**ADDENDUM 1
RFB #22-0075
EMERGENCY COMMUNICATIONS REMODEL**

**SEDGWICK CO PUBLIC SAFETY CENTER –
EMERGENCY COMMUNICATIONS CENTER REMODEL
Sedgwick County**

Prepared by:
Schaefer Johnson Cox Frey Architecture, Inc.

1 DEMOLITION PLAN
1/8" = 1'-0"

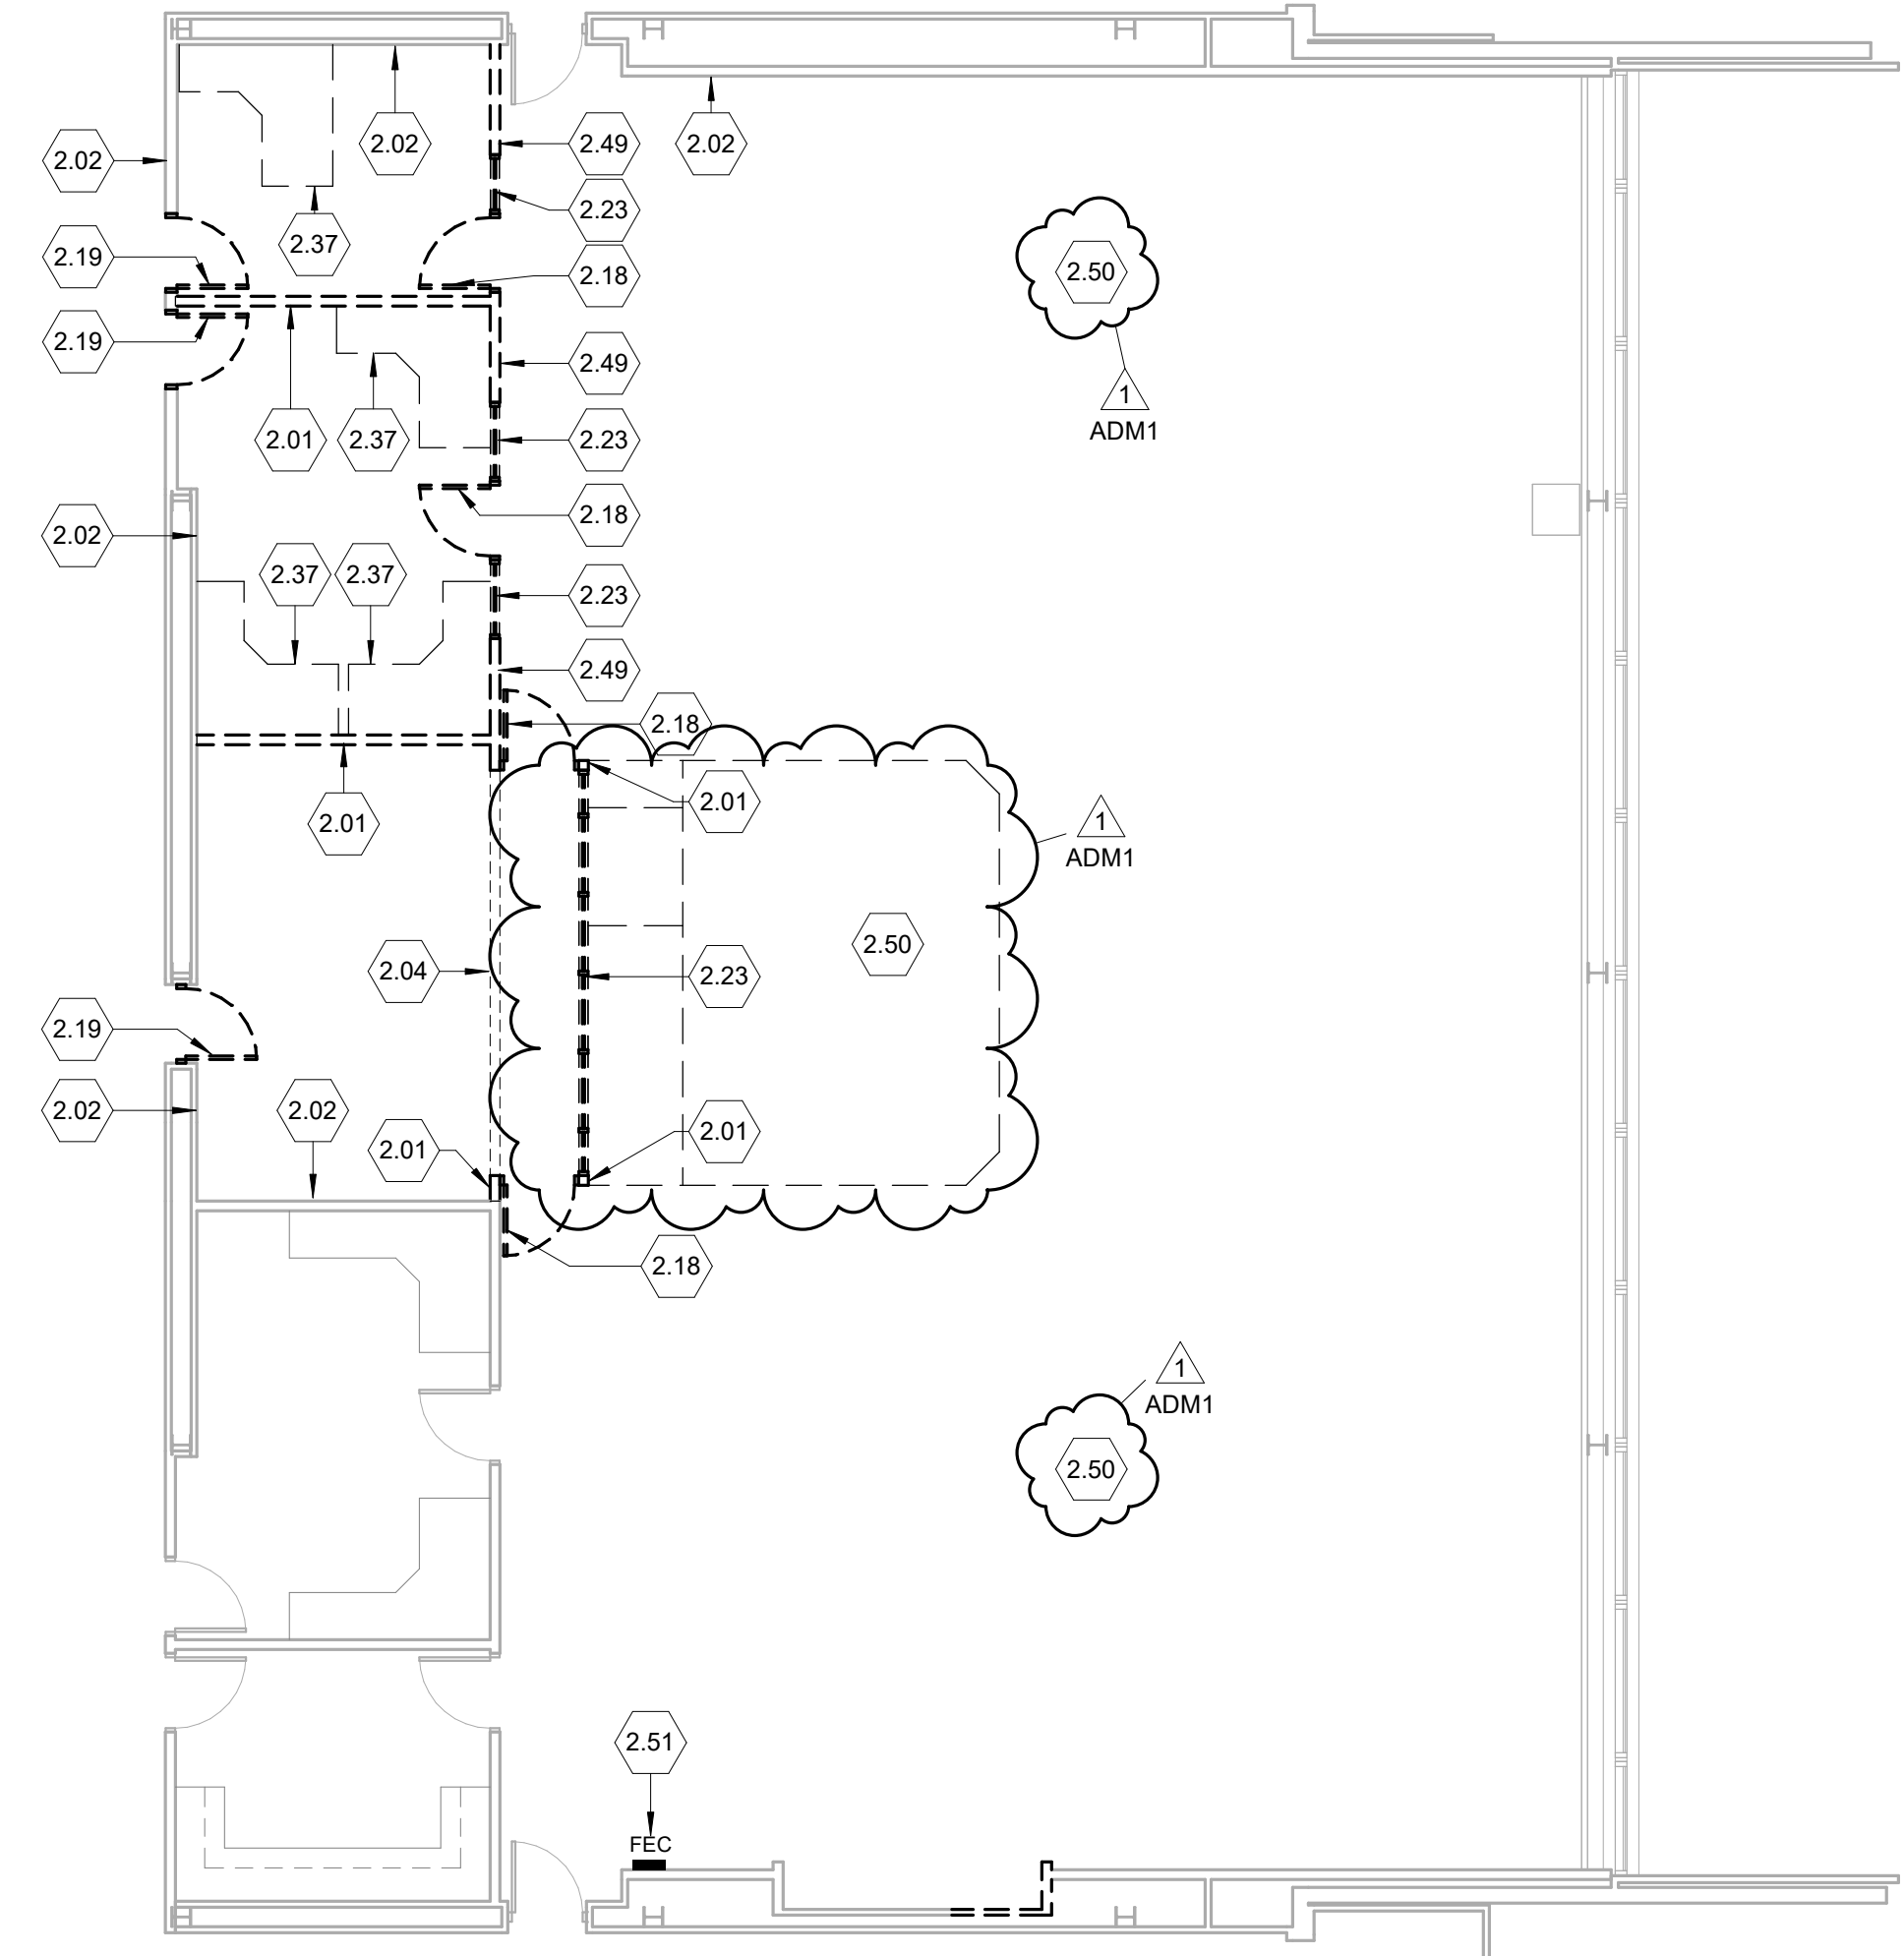
ADD: 1-Demolition Plan: Add keyed note 2.50 and outline of existing supervisor platform. 'Keyed Notes': Add note 2.50.

2 FLOOR PLAN
1/8" = 1'-0"

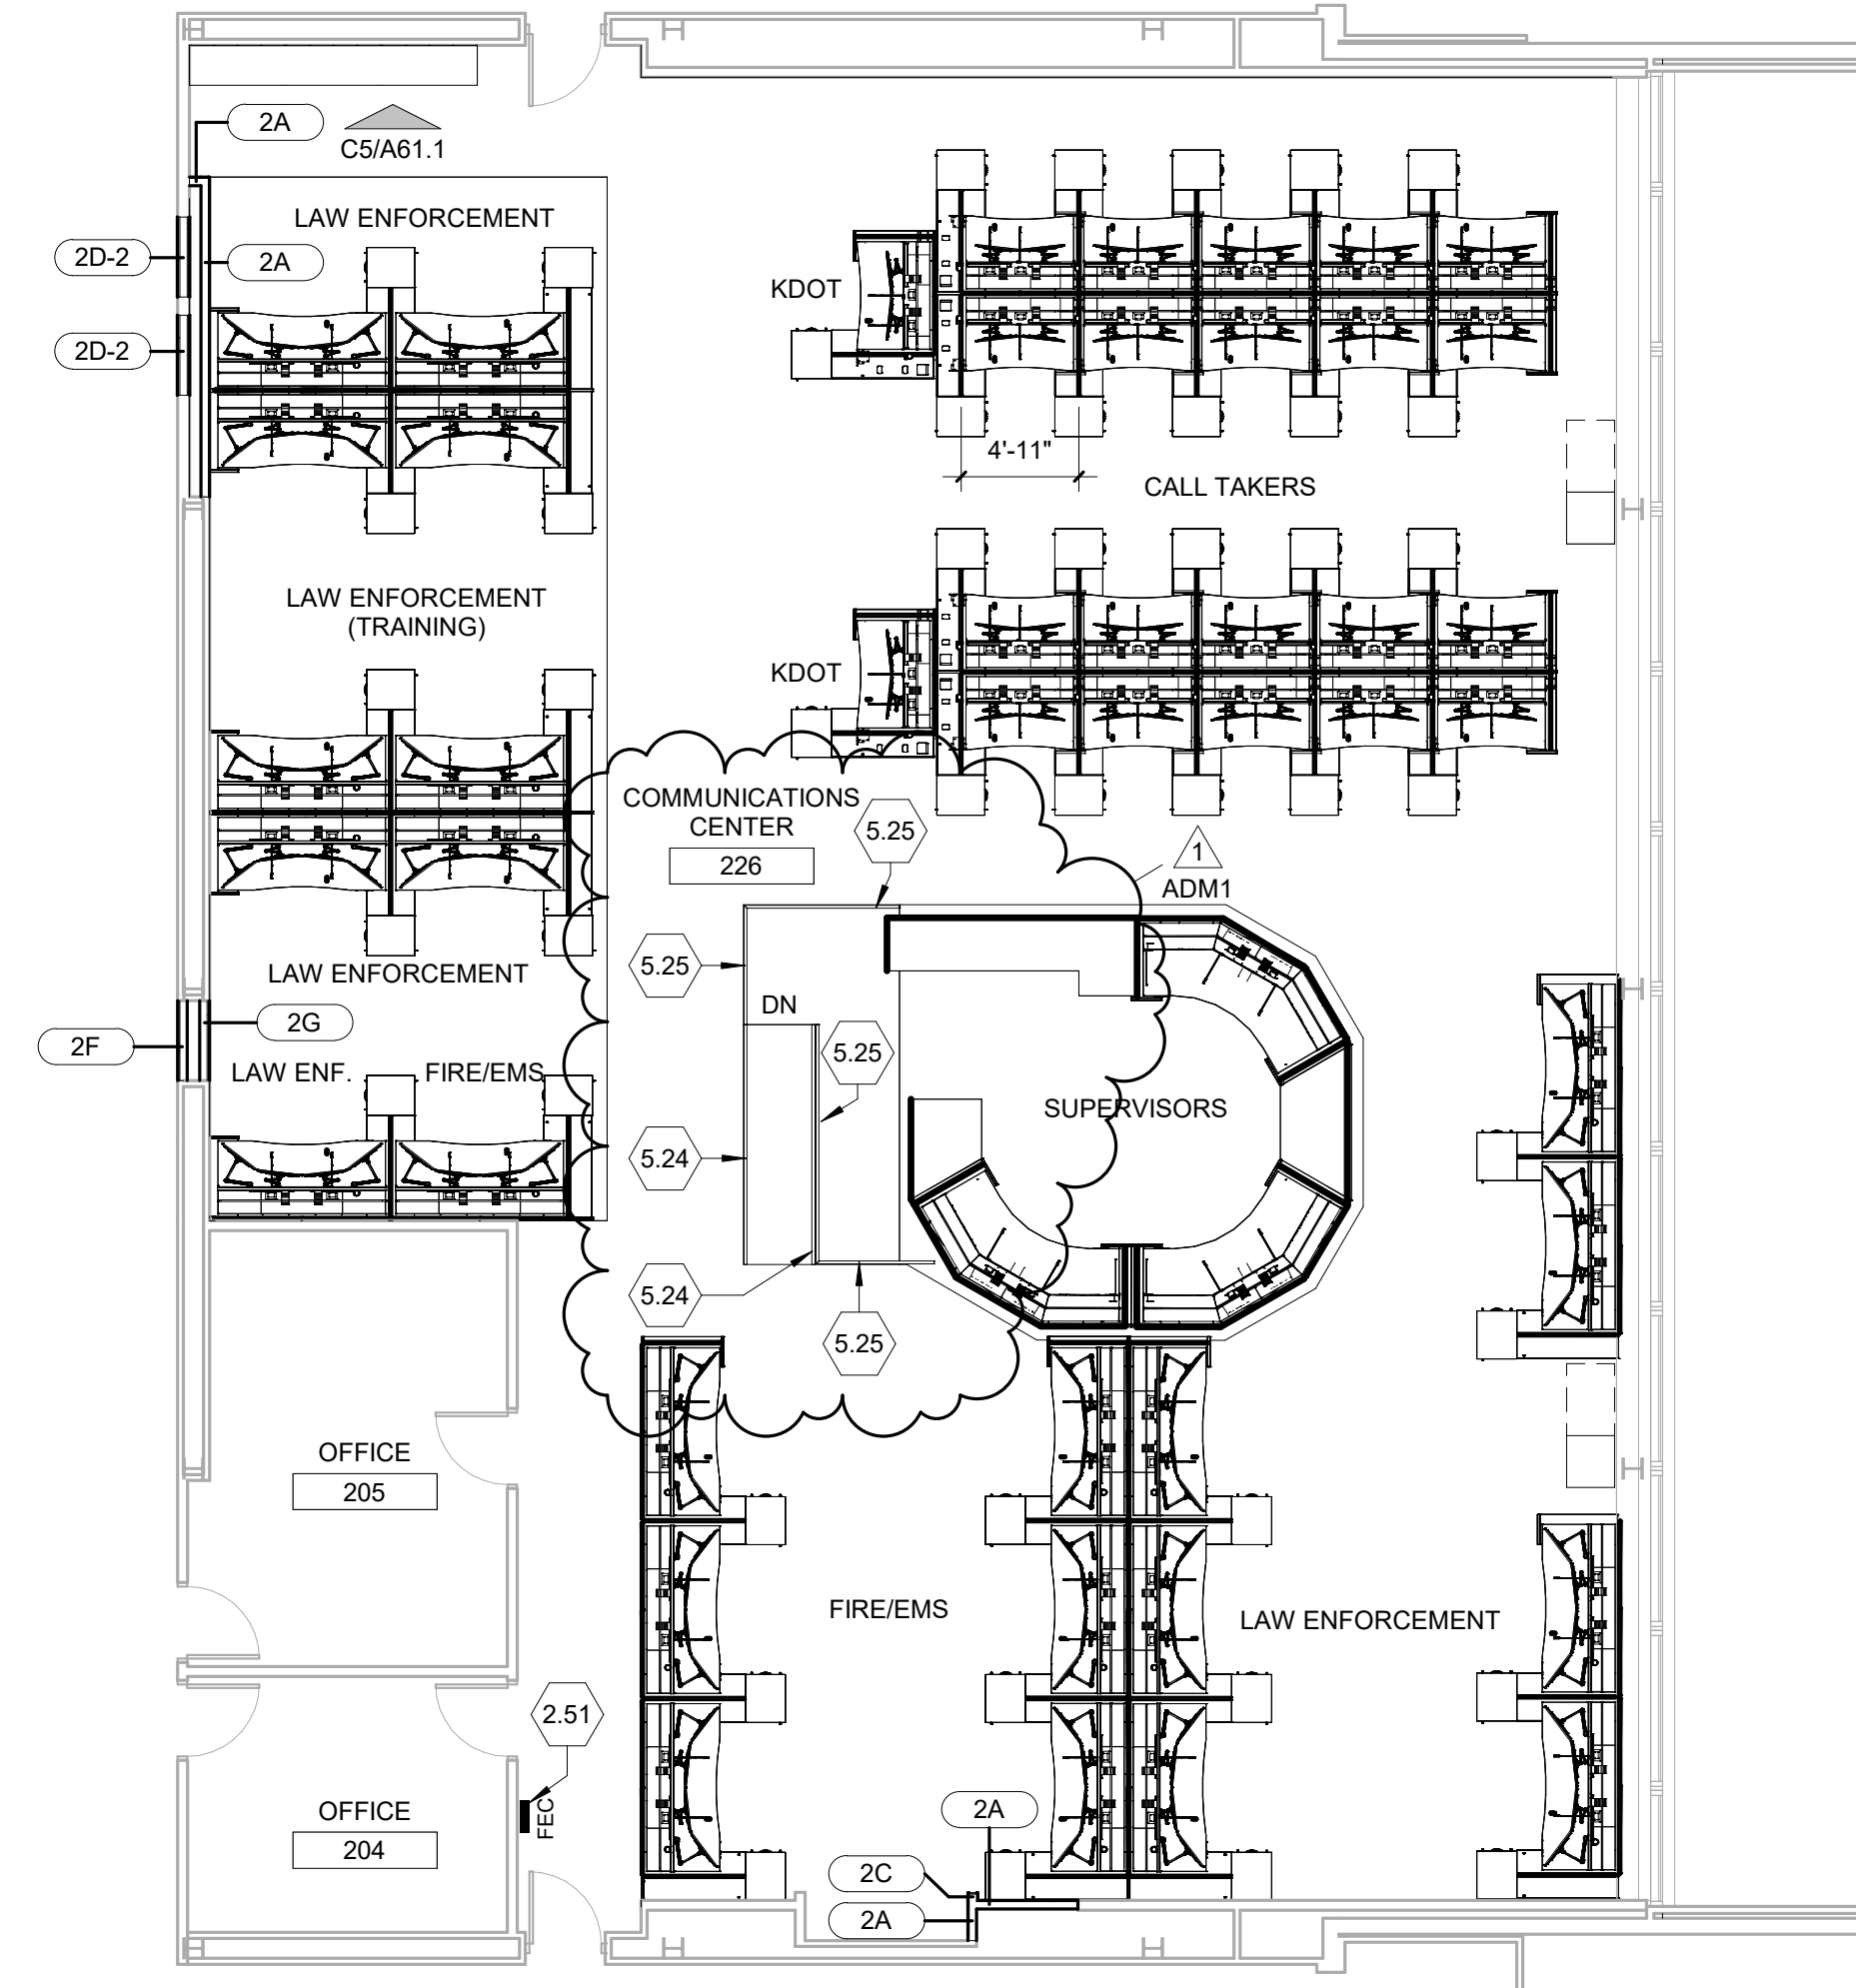
ADD: 2- Floor Plan: Add keyed notes 5.24 & 5.25 at supervisor platform. Furniture at supervisor platform revised. 'Keyed Notes': Add notes 5.24 & 5.25.

1 RAISED FLOORING PLAN
1/8" = 1'-0"

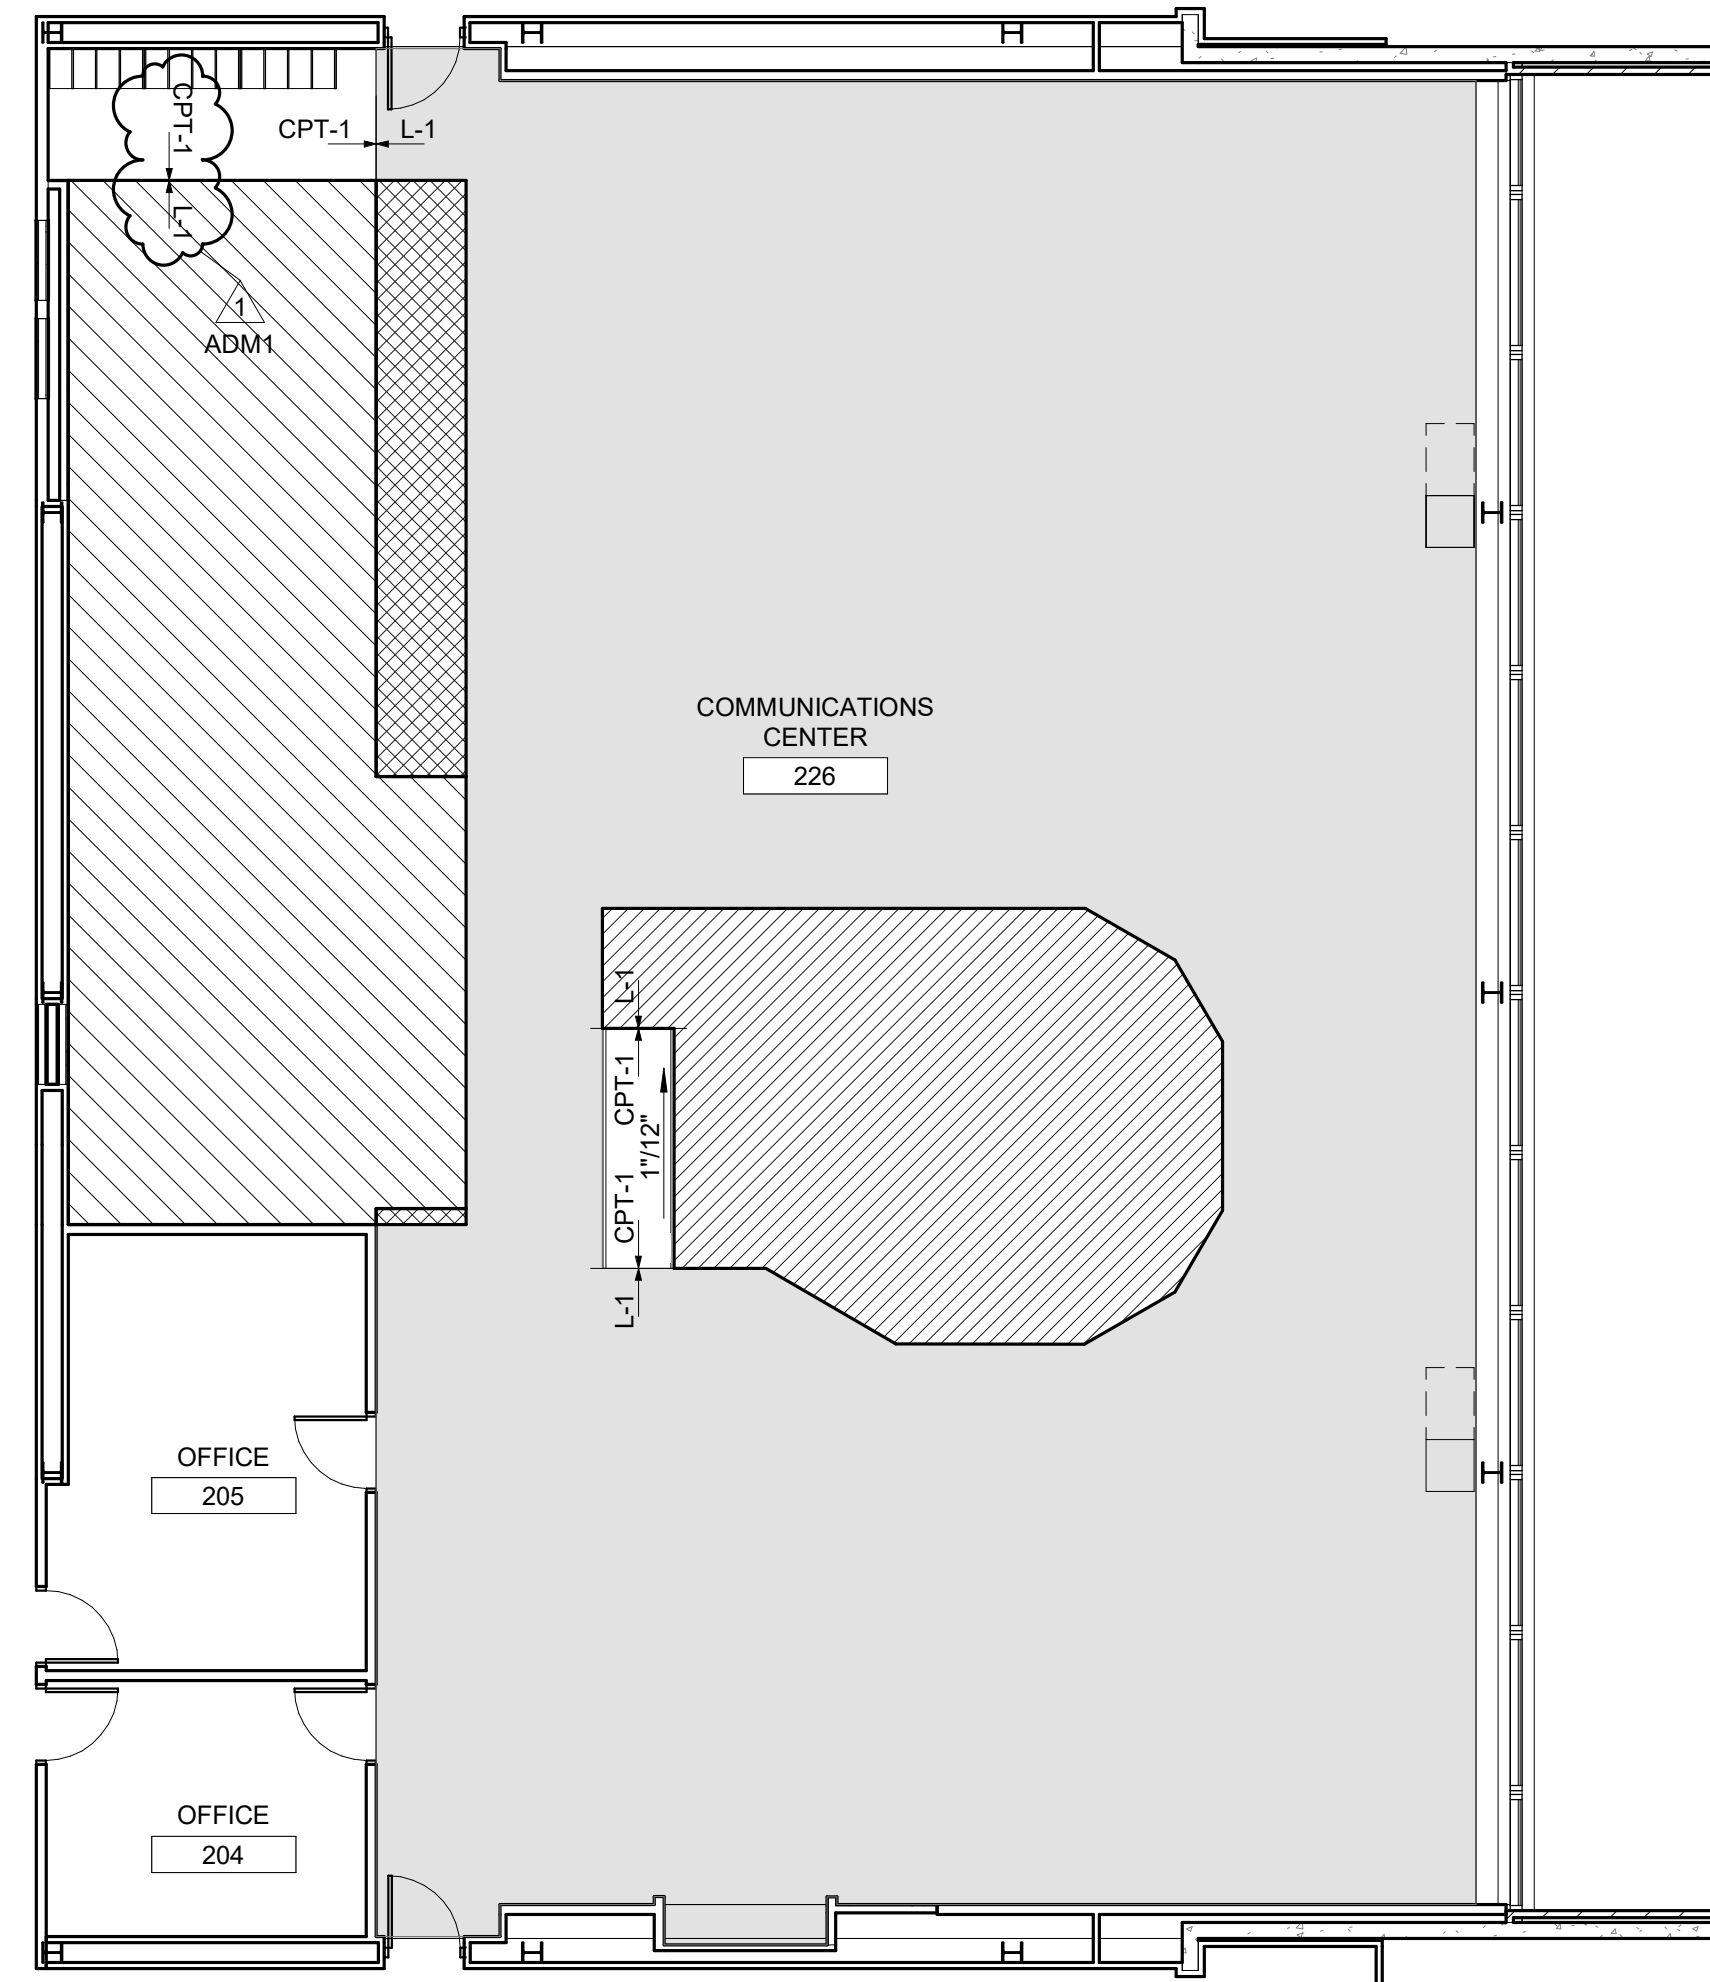
OMIT: Raised Floor Symbol Legend: Omit "EXISTING" from second note down.

CLARIFICATION: Only mail center area and supervisor platform ramp shall be carpet. All flat raised flooring sections shall have L-1 flooring. Additional transition tag added for clarification.
